Application No.: 10/630072
Amendment dated: September 9, 2004
Reply to Office action of March 9, 2004

REMARKS/ARGUMENTS

AMENDMENT TO THE DRAWINGS

Fig.5

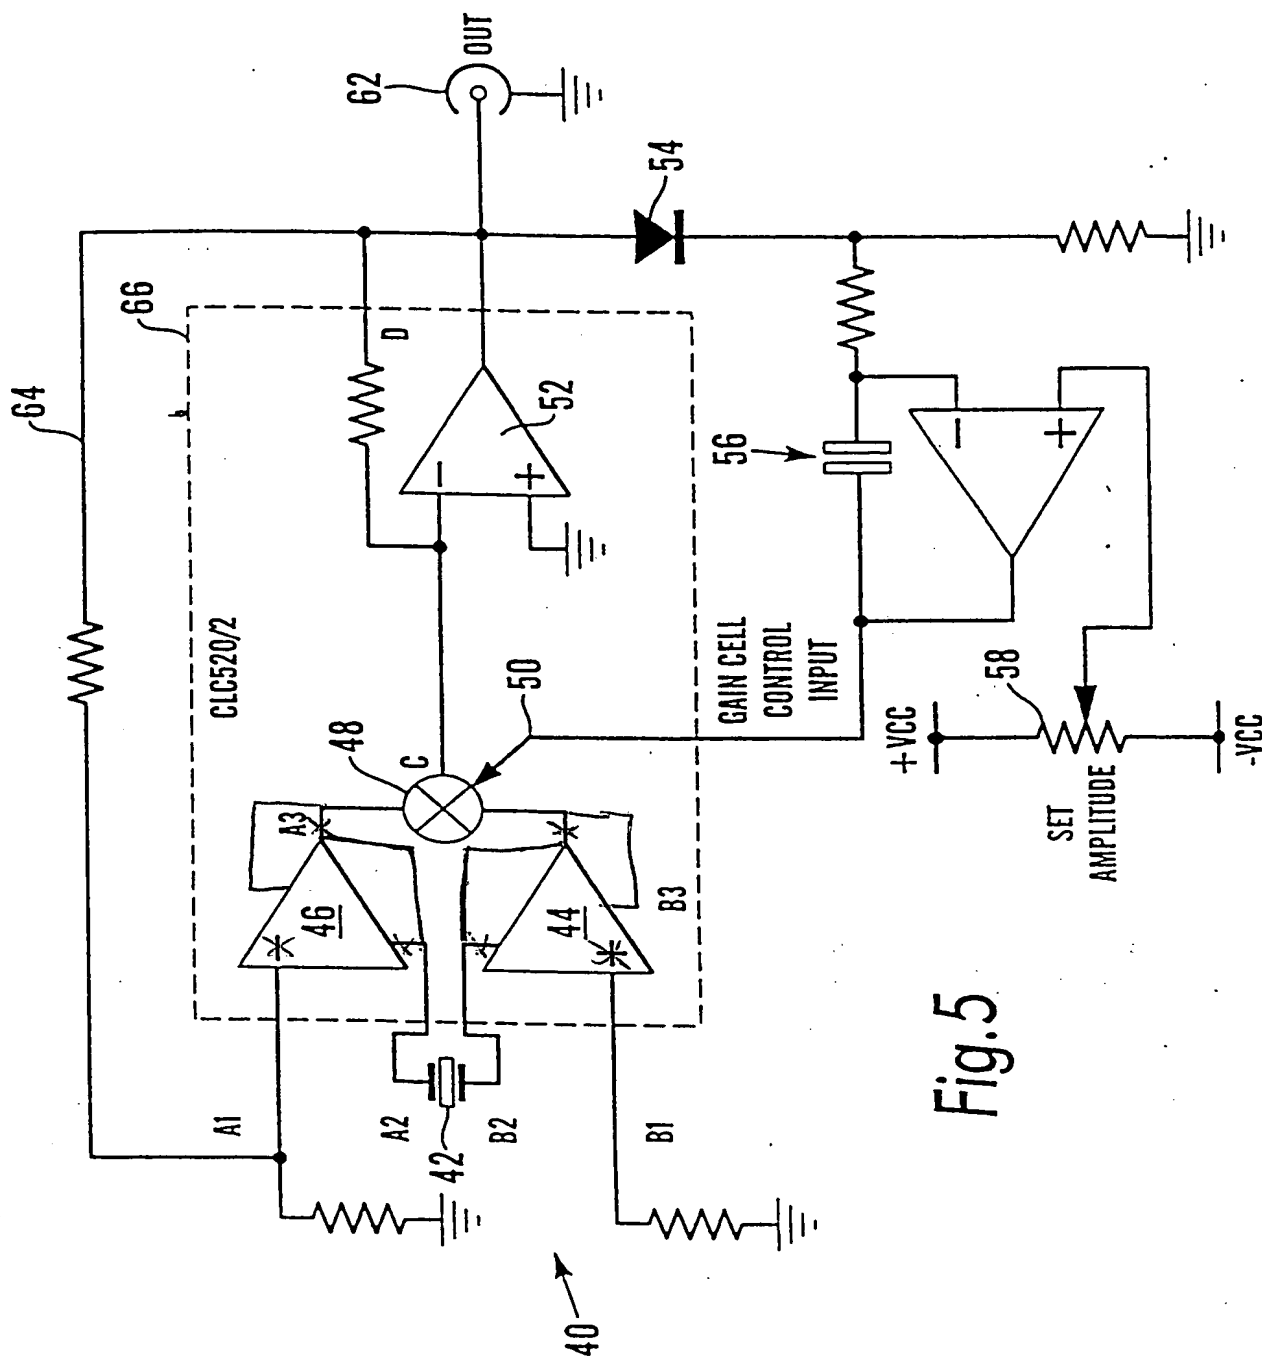
Please substitute the attached replacement sheet bearing FIG. 5 for the corresponding original drawing sheet. An annotated sheet showing the changes is also attached. The change is the interchange of the outputs of each of the two buffers. This change brings FIG. 5 into conformity with FIG. 4a, as required by paragraph 0034.
